DEV NUMBER: ORIGINATOR:		DATE	E:	RAIN BIRD		BUSINESS UNIT (SBU and PLANT) W/ PRIMARY DESIGN CONTROL: SHEET:											
DEV25-0113		Α	bdul Castil	llo		25-Mar-25				025 OTY >>		>>>	GLF	L	or 7		
DMR# (IF APPLICABLE): DEVIATION NEW ✓				DE	VIATIO	ON FOR	M (DRAWING)						1	OF 7			
TYPE: EXTENSION OF DEV#:										AFFEC1	TED MFG PI	LANTS (WHERI	E USED):				
TOP-LEVEL SKU P/N(S) AND MODEL NUMBER(S):					EFFE	CTIVITY D	ATE: E	XPIRATION DATE:	005 1	LAM 🔲	013S STL		025 OTY 🔽	041 NO	G 🔲		
Golf: All Rotors						25-Mar-	25	25-Jun-25	008	BUY 🔲	019 AZU		028 TUC	047 TU	c 🗖		
PROJECT NAME OR NO. (OPTIONAL):										013E	EEX 🔲	020MX NMD		026 ELG 🔲		IA 🗖	
REASON FOR DEVIATION:											, <u></u> '			APPROVALS (ALL RE	QUIRED)		
Allow to run the 2149	30 low c	apability (PP	K) QAP; no	data is out of s	pecification	. Additional sh	neets for	the proces	s capability	report. This version allo	ws for the	use of 2149	30 components	with poor	QUALITY MGR. OR QU	IALITY E	NG.

DRAWING NUMBE	ER. L	DRAWING REVISION: DEVIATION REVISION: DRAWING T			IILE/ PA	KI DESCI				VENDOR:		PLANT MANAGER					
214930		С		C2					Bearing F	Housing			Westfall	· · · · · · · · · · · · · · · · · · ·	Jorge B		
															SBU PROD

Process Capability Report for 2.859+/-.005

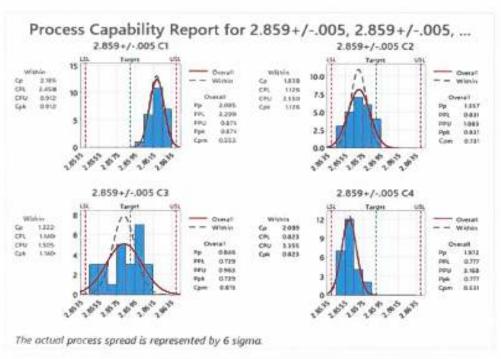
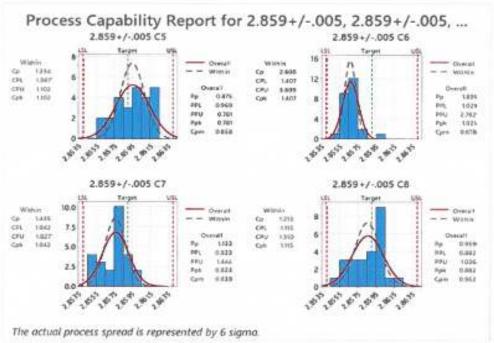
Deviation 24-0154 5/2/2024	Deviation 24-0184 5/23/2024	Deviation 24-0397 10/23/2024	
0.116 +0.006/-0.004		0.116 +0.007/-0.004	0.116 +0.007/-0.004	
2x 0.16 +/-0.015		2x 0.16 +0.016/-0.015	2x 0.162 +0.016/-0.015	Repair
2.233 +/- 0.009		2.233 +/- 0.015	2.233 +/- 0.015	Re
2.859 +/- 0.005				
1.315 +0.005 / -0.006 LOT: 1.314"-1.326"				
Flash?	Flash

Deviation 25-0113 3/26/2025	Proposal	Diference
Low Ppk (0.873)	0.116 +0.008/0.004 Ppk: 1.475	0.001"
Low Ppk (0.674)	2.233 + 0.016 / -0.015 Ppk: 1.411	0.001"
Low Ppk (0.777)	2.858 +/- 0.011 Ppk: 1.59	0.006"
Low Ppk (0.717) LOT: Ppk (0.310)	1.315" +0.009" / -0.007" Ppk: 1.684	0.005"

Process Capability Report for 2.233+/-.009

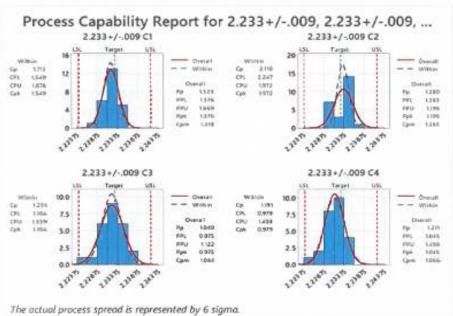
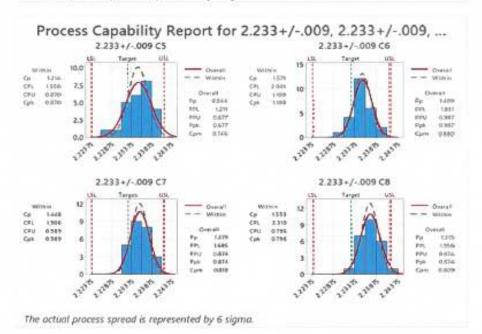
Permit the usage of the low capability (PPK) QAP run of 214930. The process capability report on xtra sheets shows that the most recent fix only affected cav 5, 6, 7, and 8. With this deviation, 214930 parts with a low capability PPK can be used. Under DEV24-0184 & DEV24-0397, deviations of $2.233 \pm .009$ & .116 + .006 - .005 were formerly permitted.
